Model: UD9004

Subject: Correction of power supply circuit. (For SACD Block power supply +3.3V)

8U-310010 (FE/SACD UNIT)
Component side

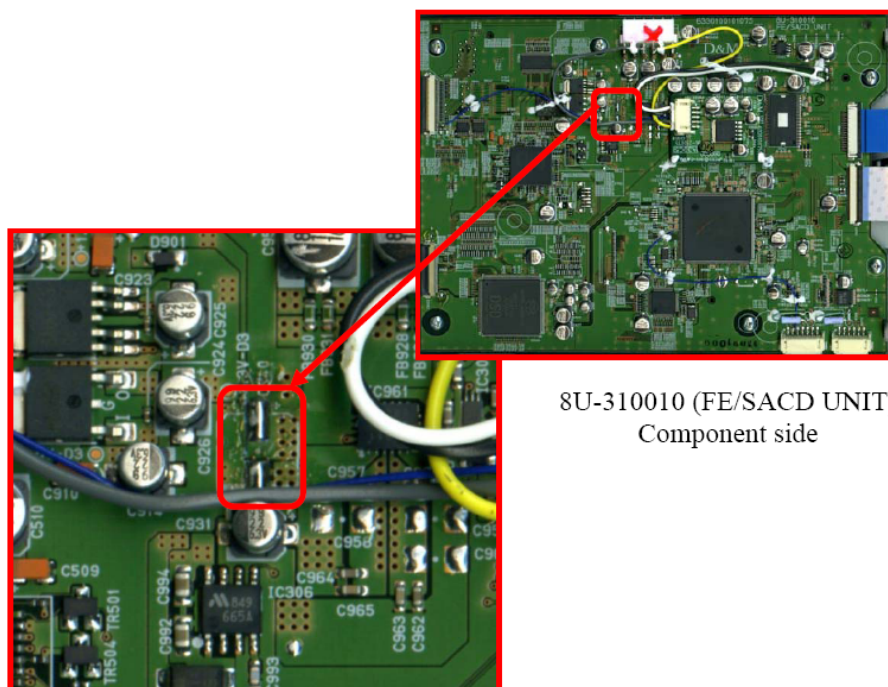
Symptom: When a SACD disc is played, "LOADING" or "NO PLAY" might be displayed.

Solution: COUNTERMEASURE: Remove C940 (Electric capacitor) located on 8U-310010 (FE/SACD UNIT). Please confirm playback of the SACD disc after removing the C940.
